A G E N D A
JAMES CITY COUNTY DEVELOPMENT REVIEW COMMITTEE
REGULAR MEETING
Building A Large Conference Room
101 Mounts Bay Road, Williamsburg, VA 23185
April 27, 2016
4:00 PM

SUBJECT: SITE PLAN-0104-2015, Williamsburg Landing Woodhaven Expansion

SITE PLAN-0104-2015. Williamsburg Landing Woodhaven Expansion
Staff Report for the April 27, 2016, Development Review Committee

ENGINEERING AND RESOURCE PROTECTION REVIEW COMMENTS
Williamsburg Landing, Inc. – Woodhaven Expansion
COUNTY PLAN NO. SP – 104 – 15
April 12, 2016

Sheet Number
L-3.1

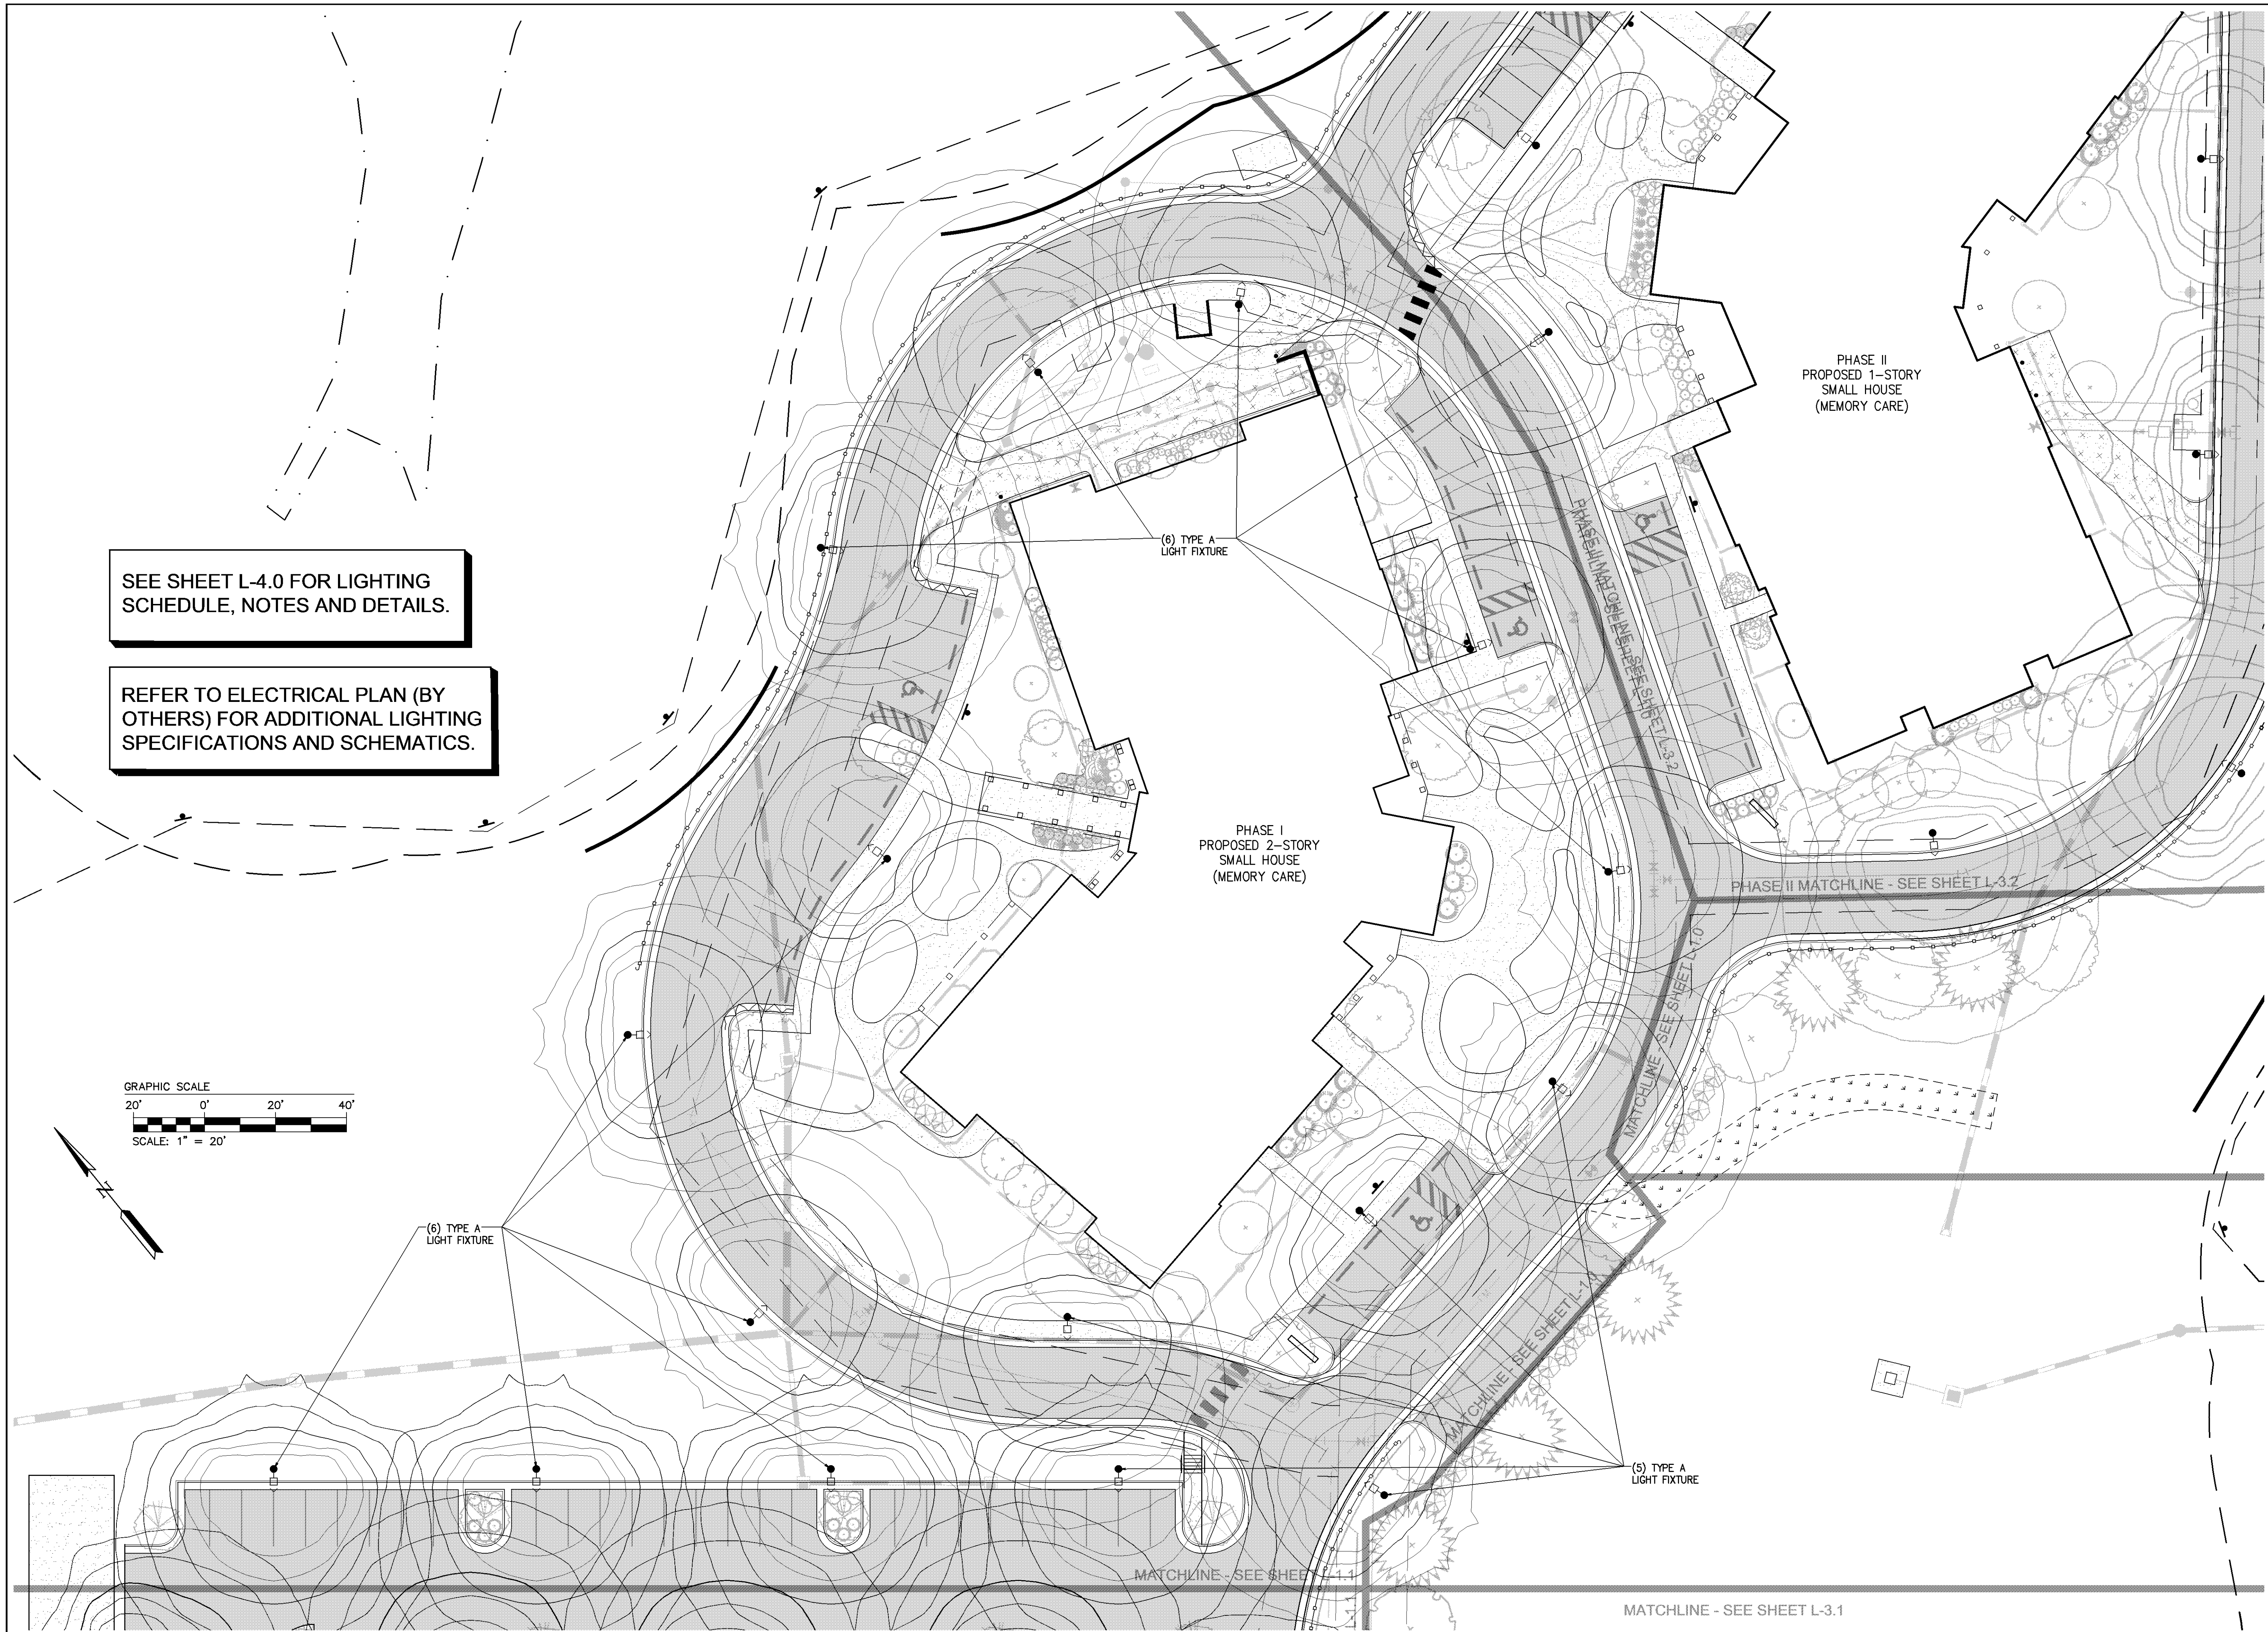
Sheet L-3.1:

26. There is a light pole shown very close to an existing fire hydrant located in an island at the end of the parking lot north of the new building addition. There should be a minimum distance of 5' from the outside edge of the water main to the outside edge to the light pole. Verify if there is minimum clearance.

Sheet Number: **6**

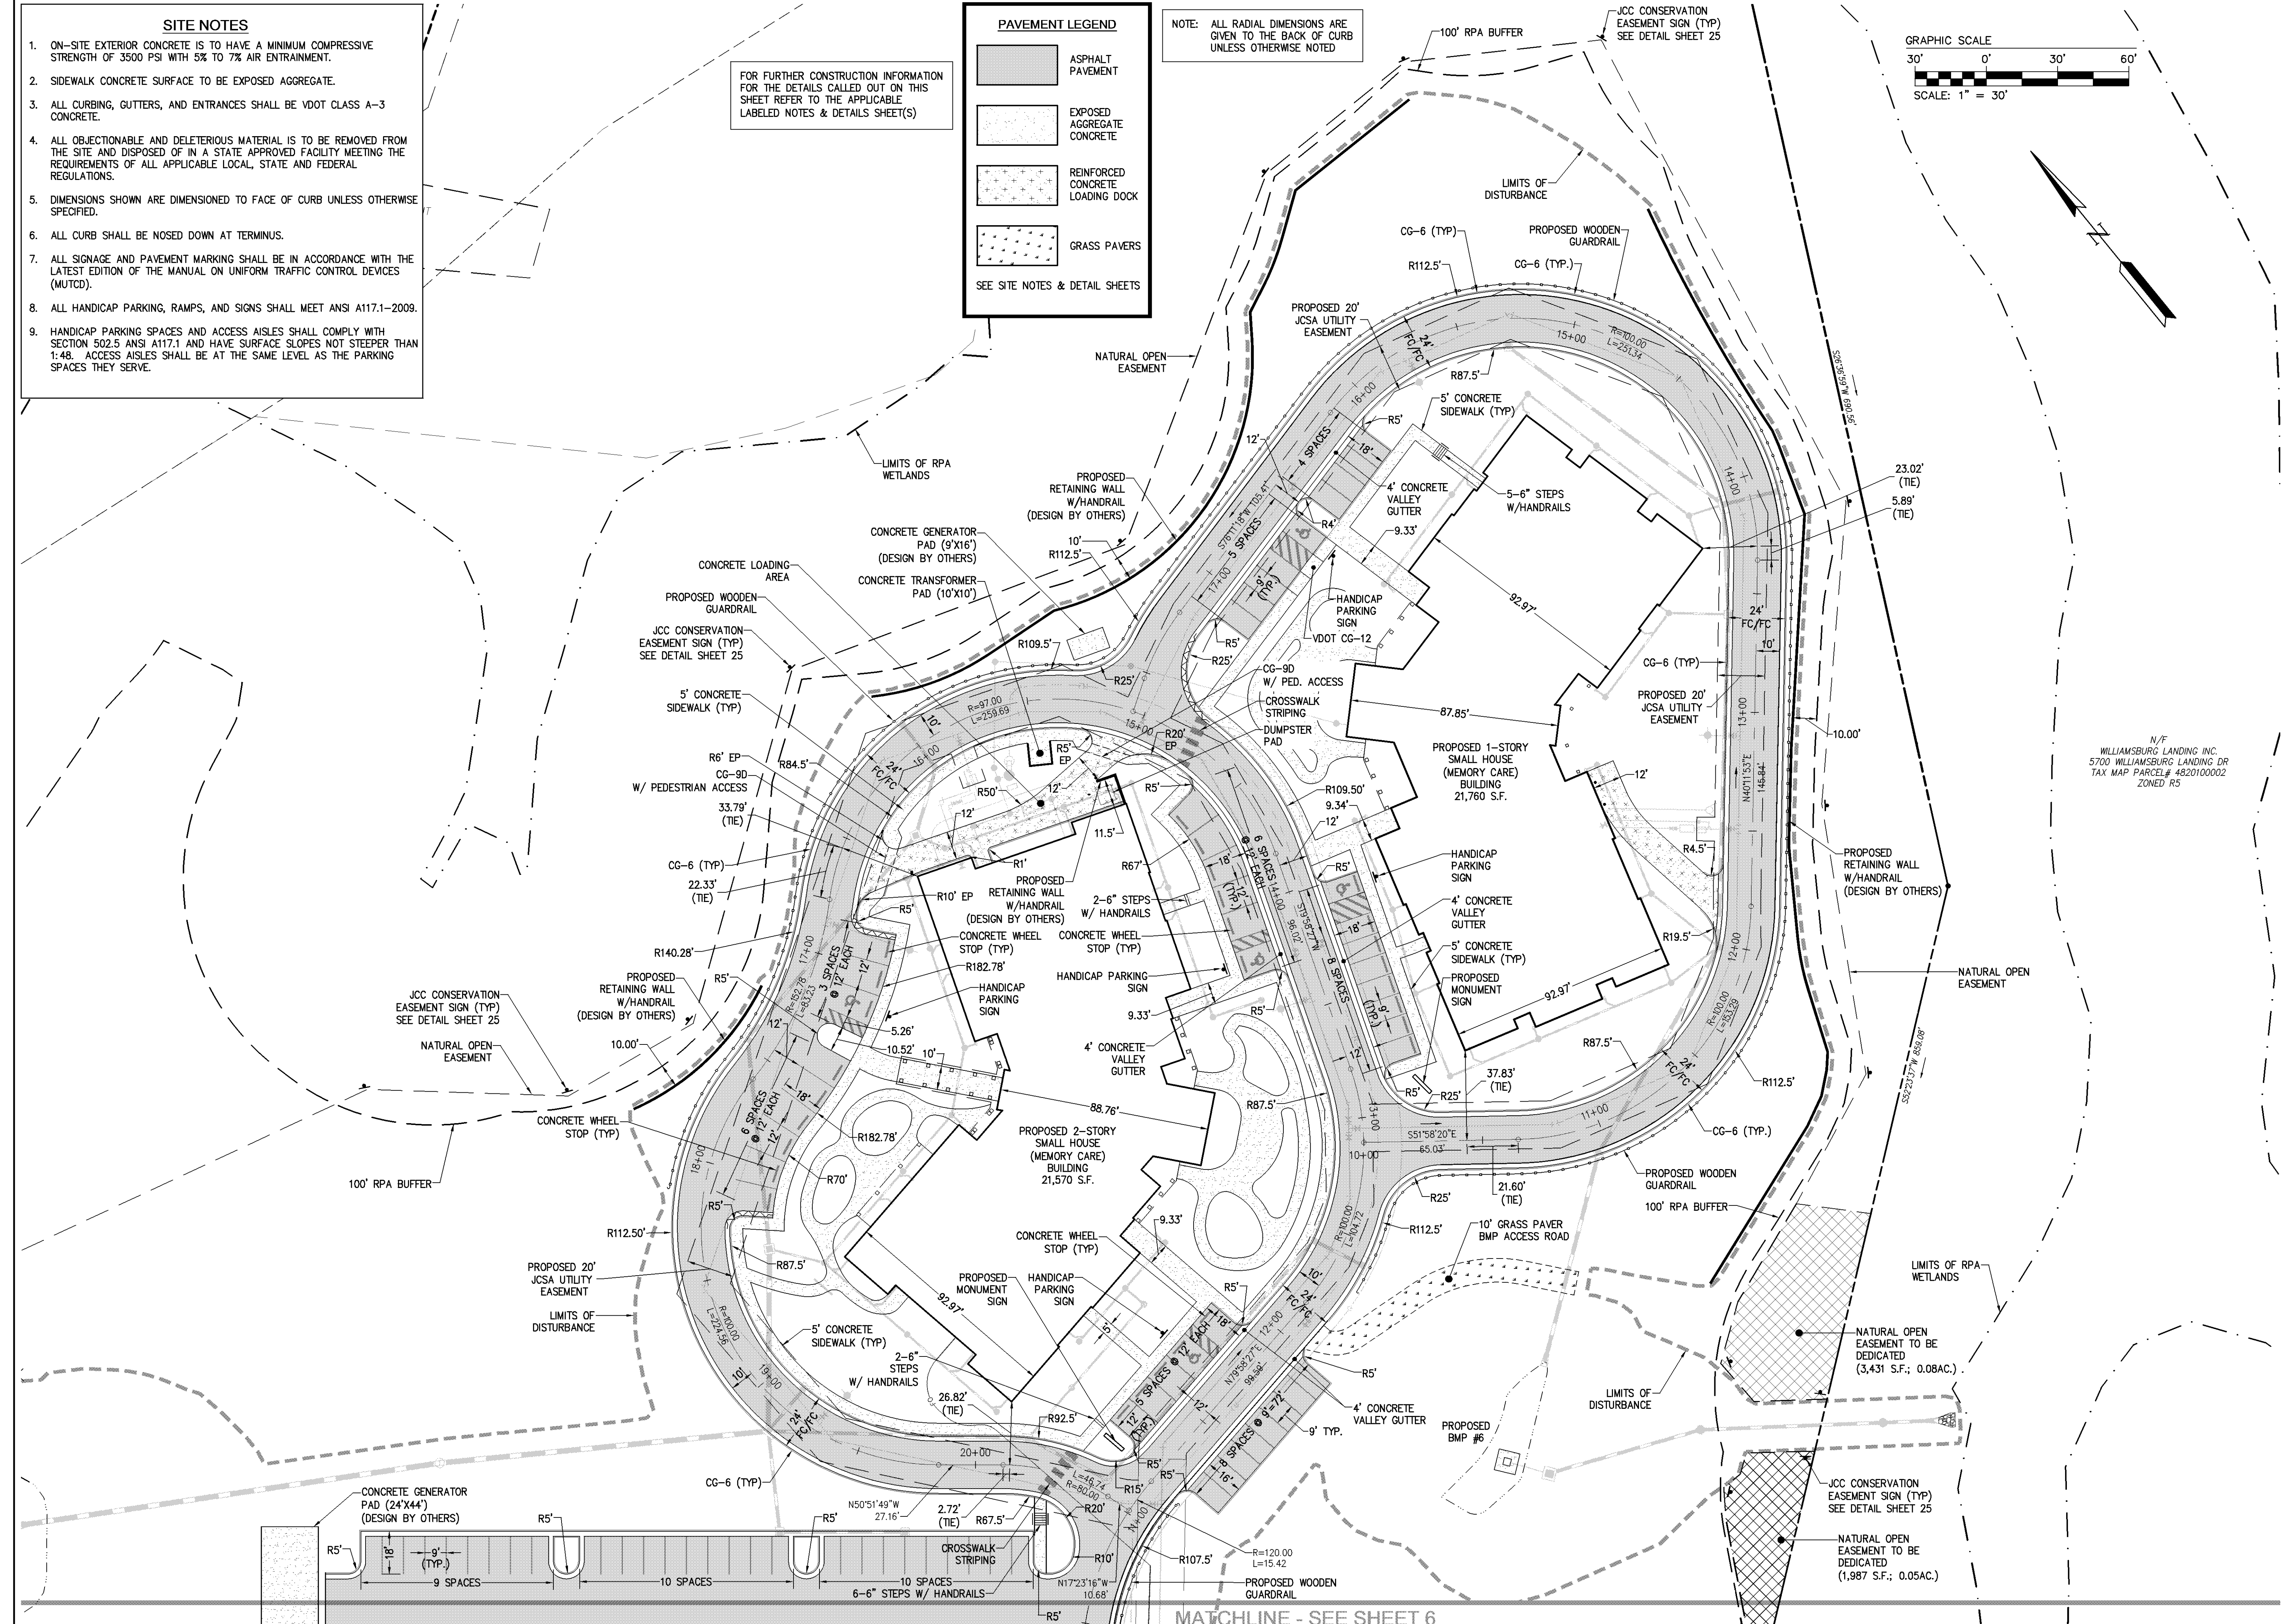
5. *Existing Parking:* Though the response letter states that all parking has been redesigned to meet current Ordinance standards, staff notes existing parking shown on Sheet 6 which is not in conformance. As this plan proposes an increase in parking spaces which is over 15% of the existing provided parking, the existing parking areas must also be brought into conformance with current Ordinance standards. You may request the a waiver of this requirement according to the criteria outline in [Sec. 24-55 \(a\)\(3\)](#).
